**Scraping Noise – Front Brake Disc Shield –
Install Washer**

MODEL 1997 MY
XK8 Range
VIN
001001-005660

ILLUSTRATION 1

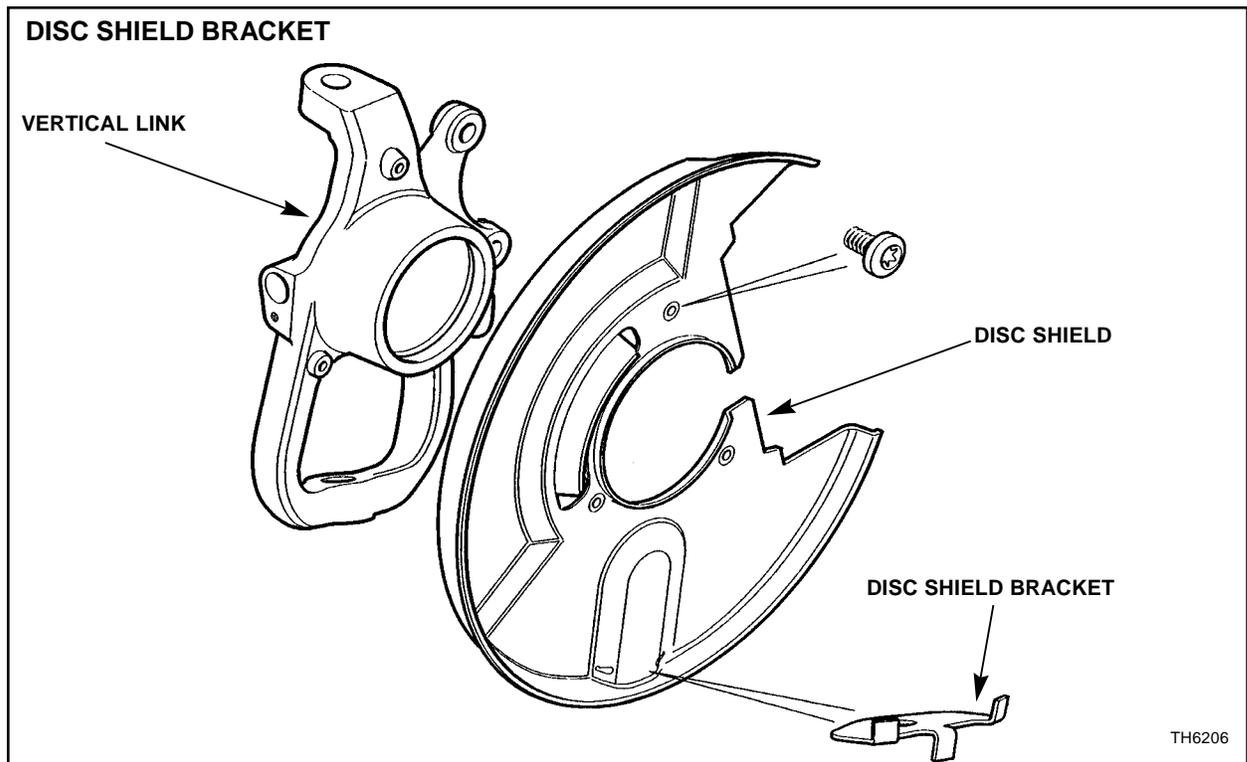
1. Remove the bottom ball joint nut.
2. Examine the bracket (Illustration 1) for possible cracks or other damage.

3. Eliminate any distortion in the shield.
4. Install a washer, part no. WA 112081/J, then the ball joint retaining nut.
5. Make sure that the bracket does not twist as the nut is tightened. Torque to nut to 52 lb. ft. (70 Nm.)
